82527

SPECIFICATION UPDATE

Order Number 272876-001

9600001. Fast Read Data Corruption

Figure 1: Bus cycle for Mode 0 or Mode 1 Operation (Read Cycle)

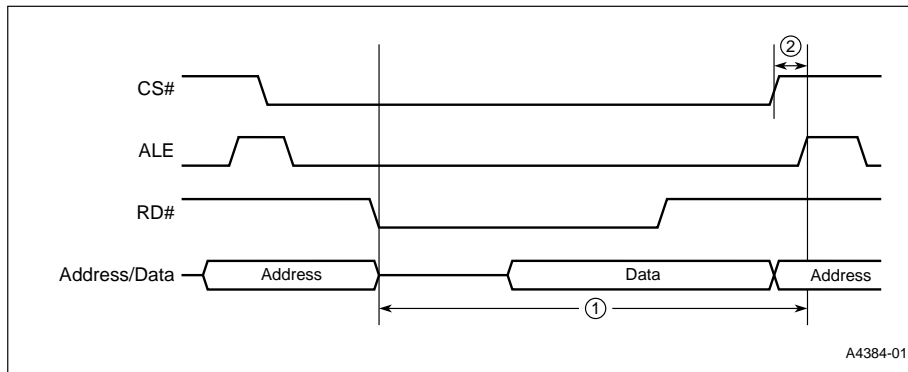
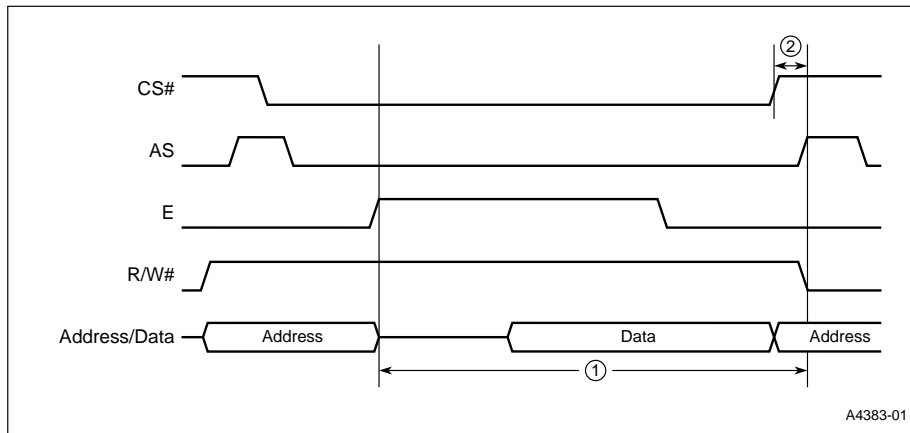
For mode 0 and mode 1 (Intel multiplexed modes), the control signals ALE, RD# and WR# are used to define the address and whether the cycle is a data read or write operation. The ALE signal is commonly used to latch the address information and generate a CS# signal to the 82527. The problem occurs in this configuration when the next cycle ALE is asserted before CS# of the current cycle becomes invalid. This circumstance presents a problem only when CS# is active and the next cycle's ALE occurs less than $1.5 t_{MCLK}$ after the current cycle's RD# low. ($t_{MCLK} = t_{OSC} / [(1 + DSC \text{ bit}) + DMC \text{ bit}]$ where DSC = Divide System Clock, DMC = Divide Memory Clock.

When performing “fast reads” associated with the double-read operation in mode 0 or 1, one of the following two conditions must be true:

- 1) The time from RD# low of the current cycle to the next ALE must be greater than $1.5 t_{MCLK}$, or
- 2) The CS# signal to the 82527 must be inactive before the next occurrence of an ALE, when the time from the RD# low of the current cycle to the next cycle's CS# active is less than $1.5 t_{MCLK}$.

Figure 3: Bus Cycle for Mode 3 Synchronous Operation (Read Cycle)

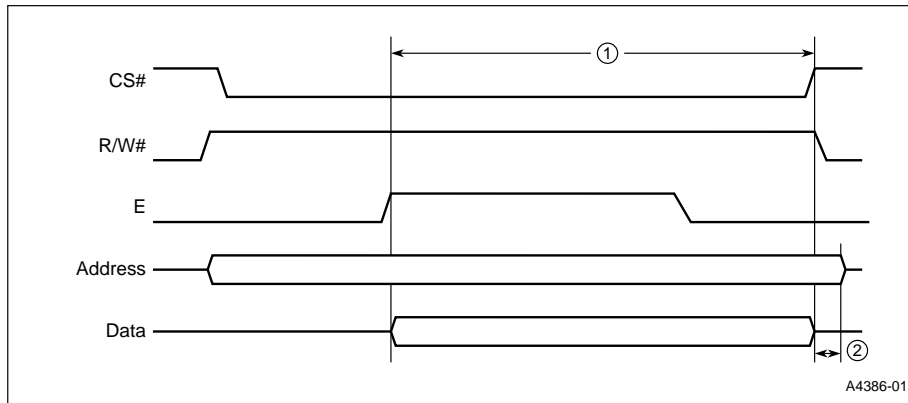
For mode 3 synchronous operation, there is no ALE or AS signal. Mode 3 is the demultiplexed mode of the 82527. For this mode, the address information must be present through the entire cycle. However, when performing fast read operations, similar considerations as the other modes must be observed to prevent problems when performing reads from the 82527.

For mode 3 synchronous operation, one of the following two criteria must be true:

- 1) The time from E high of the current cycle to CS# invalid must be equal to or greater than $1.5 t_{MCLK}$ or
- 2) Address information must remain valid on the bus until after CS# goes inactive.

Figure 4: Bus Cycle for Mode 3 Asynchronous Operation (Read Cycle)

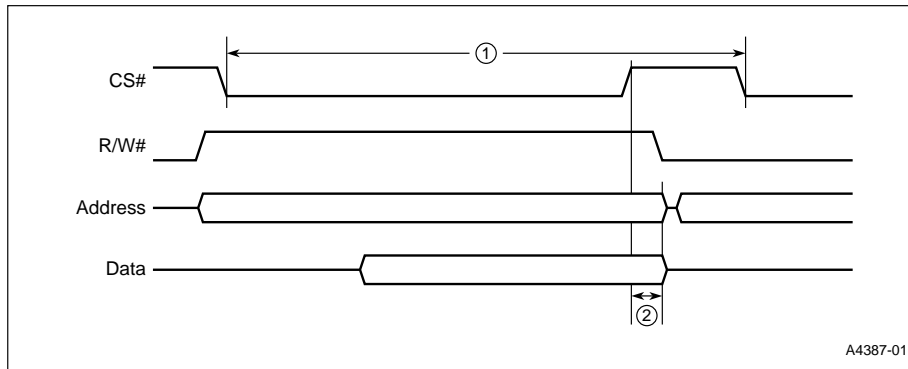
Mode 3 asynchronous is also a demultiplexed mode of operation on the 82527. This mode is typically used with the DSACK0# signal. When using mode 3 asynchronous with host CPUs that do not have the DSACK0# input, the following considerations must be observed to prevent problems when performing reads of the 82527.

For Mode 3 asynchronous (no DSACK0#), both of the following criteria must be true:

- 1) The time between consecutive CS# cycles must be equal to or greater than $2 t_{\text{MCLK}}$.
- 2) Address information must remain present on the bus until after CS# goes inactive.
